Re: Turkey Point Units 3 and 4
Docket Nos. 50-250 and 50-251
Response to Request for Additional Information for
Proposed License Amendments – Administrative Update of Technical Specifications

**PROPOSED RESPONSE TO THE NRC REQUEST
FOR ADDITIONAL INFORMATION REGARDING
AMENDMENT REQUESTS FOR AN ADMINISTRATIVE
UPDATE OF TECHNICAL SPECIFICATIONS**

**ATTACHMENT 2
CHANGES TO FPL LETTER L-2002-210,
PROPOSED LICENSE AMENDMENTS
UPDATE OF TECHNICAL SPECIFICATIONS**

FIGURE 3.4-3 Turkey Point Units 3 and 4 Reactor Coolant System Cooldown Limitations (Cooldown Rate of 0, 20, 40, 60 and 100°F/hr) Applicable for 32 EFY (Without Margins for Instrumentation Errors)

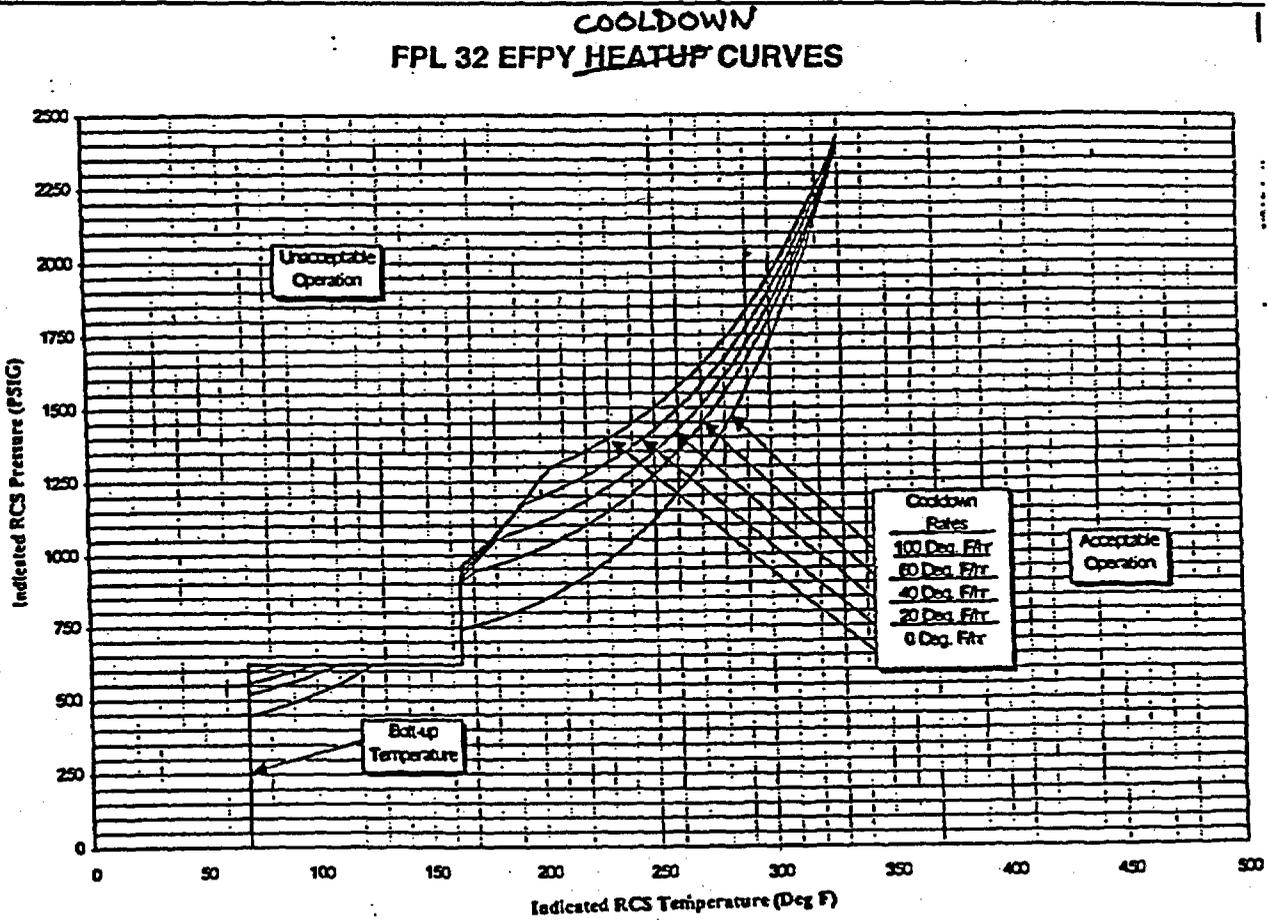
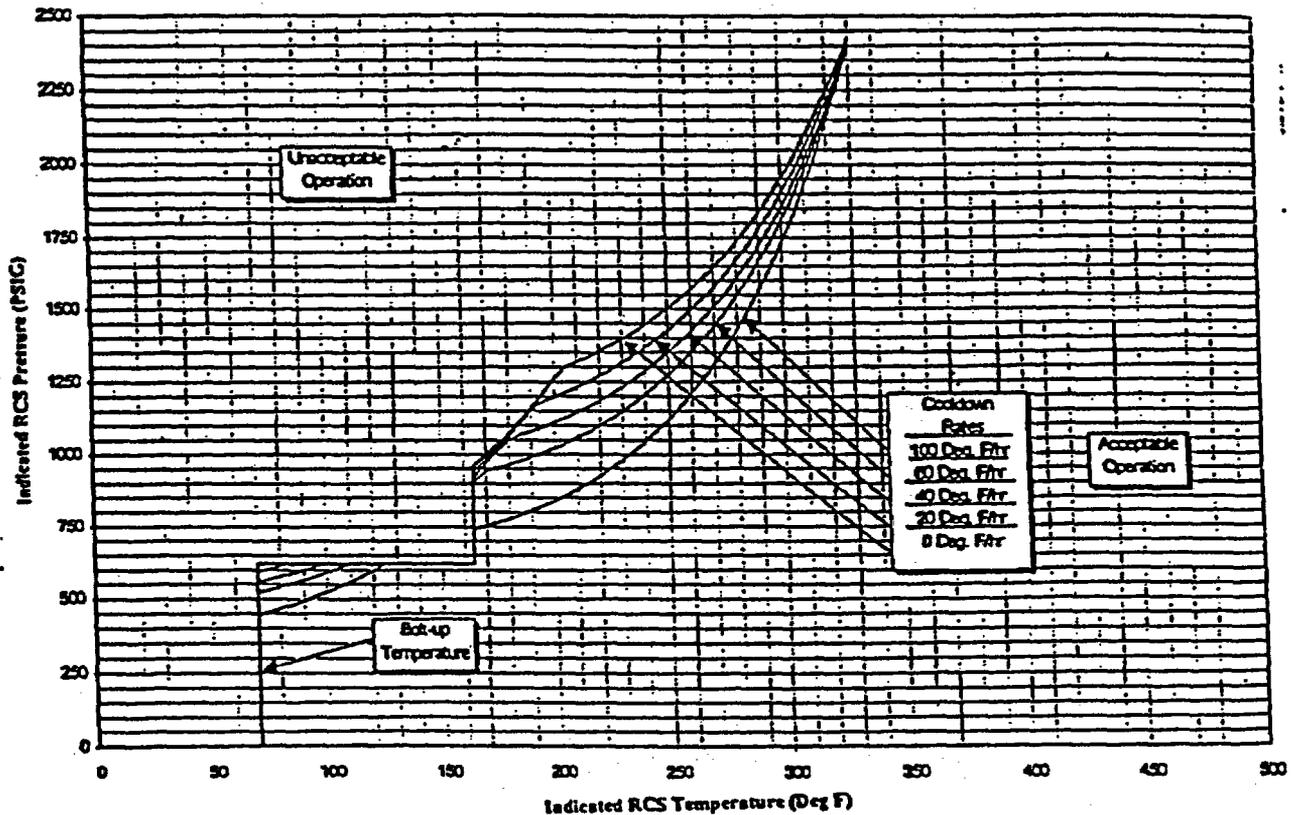
6. **Change:** On TS page 3/4 4-32, change the title of Figure 3.4-3 from [FPL 32 EFPY HEATUP CURVES] to [FPL 32 EFPY COOLDOWN CURVES]. The mark-up version of these changes is shown in Enclosure 4 as Administrative Change #6. The clean copy of this change is provided on page 3/4 4-32 of Enclosure 5.

Justification: The description provided below the Figure 3.4-3 on page 3/4 4-32 describes the figure as “Turkey Point Units 3 and 4 Reactor Coolant System Cooldown Limitations,” as such, the title above the figure is erroneously labeled as a heatup curve when it is actually intended to be used for cooldown limitations requirements.
